ECE/TRANS/WP.29/GRE/2009/13
16 January 2009

REGULATION No. 37
(Filament lamps)

Proposal for Supplement 34 to the 03 series of amendments

Submitted by the expert from the Working Party "Brussels 1952" */

Figure 1 – Main drawing

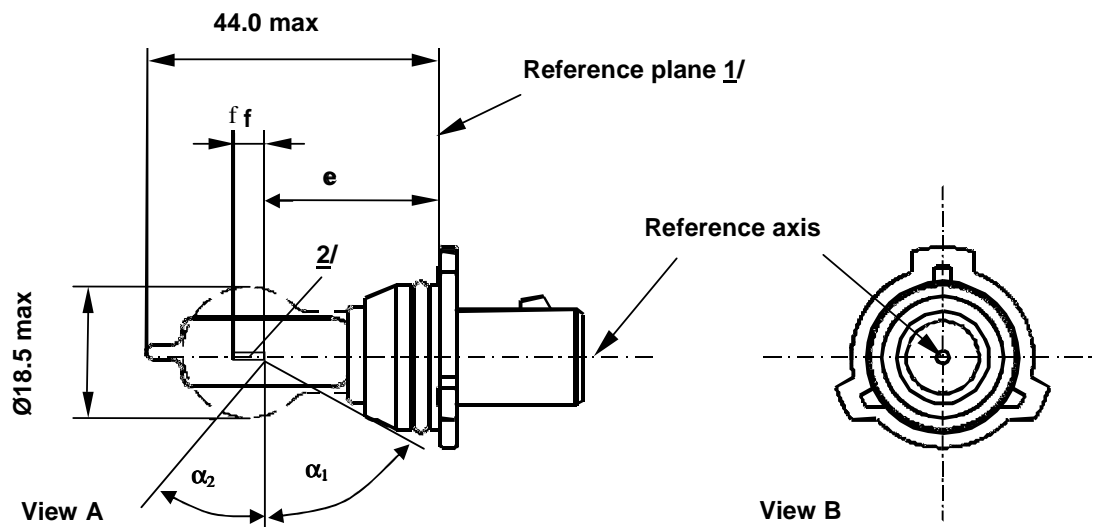
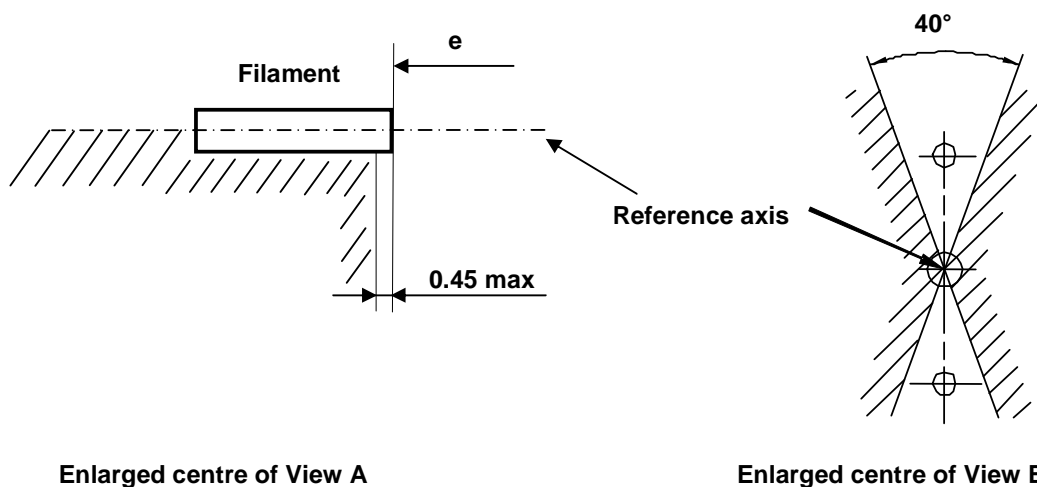
Insert new sheets PSX26W/1 to 3, between sheet PR27/7W/1 and sheet PY21W/1, to read (see next pages):

- 1/ The reference plane is defined by the meeting points of the cap-holder fit.
- 2/ No actual filament diameter restrictions apply but the objective is $d_{max} = 1.1$ mm.
- 3/ No opaque parts other than filament turns shall be located in the shaded area indicated in Figure 2. This applies to the rotational body within the angles $\alpha_1 + \alpha_2$.

Sheet PSX26W/3

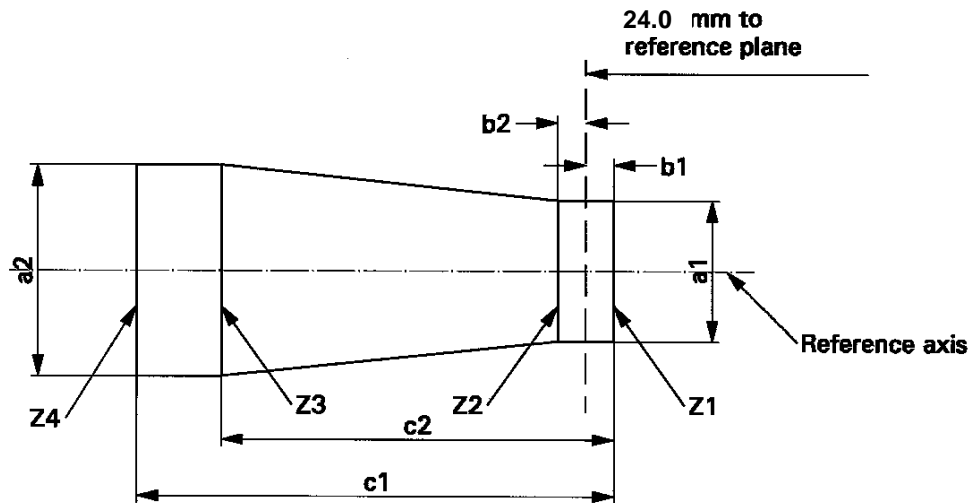
Screen projection requirements

This test is used to determine, by checking whether the filament is correctly positioned relative to the reference axis and reference plane, whether a filament lamp complies with the requirements.

The filament position is checked in two mutually perpendicular planes, one of them being the plane through the lead-in wires.

The ends of the filament as defined on sheet PSX26W/2, note 4/, shall lie between Z1 and Z2 and between the lines Z3 and Z4.

The filament shall lie entirely within the limits shown.
